Work Order ID 96979

Item Name: Crosstube Turning DetailL

DART AEROSPACE LTD	Work Order:	76979
Description: Crosstube Assembly (206L High Fwd)	Part Number:	D206-667-143
Inspection Dwg: D206-667-143 Rev: C		Page 1 of 2

DRAWING NO. D206-667-143	TITLE CROSSTUBE ASS'Y (206L HIGH FWD)	REV. C	DART AEROSPACE LTD ENGINEERING ORDER		D.E.O. NO. D206-667-143-C-1	SHEET NO. SHEET 1 OF 1	SCALE NTS
DRAWN 9P	CHECKED ASS	MFG. APPR. JES	APPROVED MD	DE APPR. JH			
DATE 11.07.15	DATE 11.07.20	DATE 11.07.21	DATE 11/07/21	DATE 11.07.21

DETAIL P
BONDING STRAP INSTALLATION 2 PL

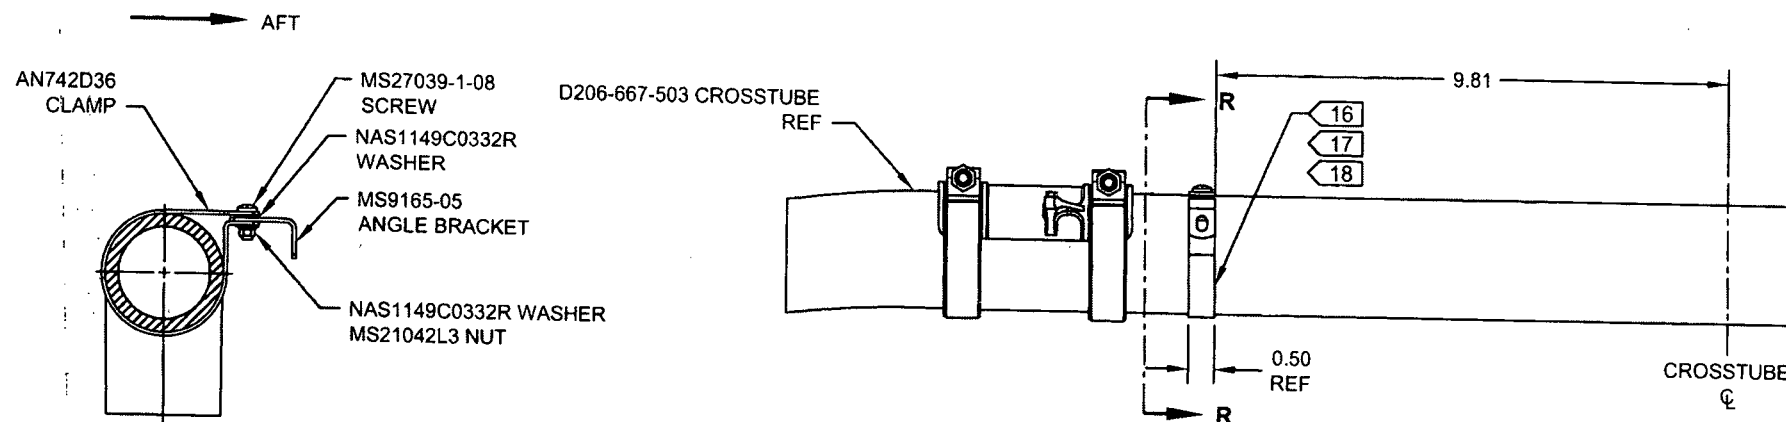
ADD ELECTRICAL GROUNDING STRAP

PARTS LIST:

ITEM	QTY -143	PART NUMBER	DESCRIPTION
1	X	D206-667-143	CROSSTUBE ASSEMBLY (206L HIGH FWD)

10	2	AN742D36	CLAMP
11	2	MS9165-05	ANGLE BRACKET
12	2	MS21042L3	NUT (OR MS21042-3)
13	2	MS27039-1-08	SCREW
14	4	NAS1149C0332R	WASHER (OR AN960C10L)

- 16) MASK AREA UNDER CLAMP PRIOR TO PAINTING
- 17) SEAL EDGES WHERE AN742D36 CLAMP MEETS WITH THE CROSSTUBE USING SIKAFLEX-241/-291 OR MIL-S-8802 CLASS B2 OR PROSEAL 890 SEALANT
- 18) PERFORM RESISTANCE CHECK TO ENSURE MAX RESISTANCE IS 10 MILLIOHMS
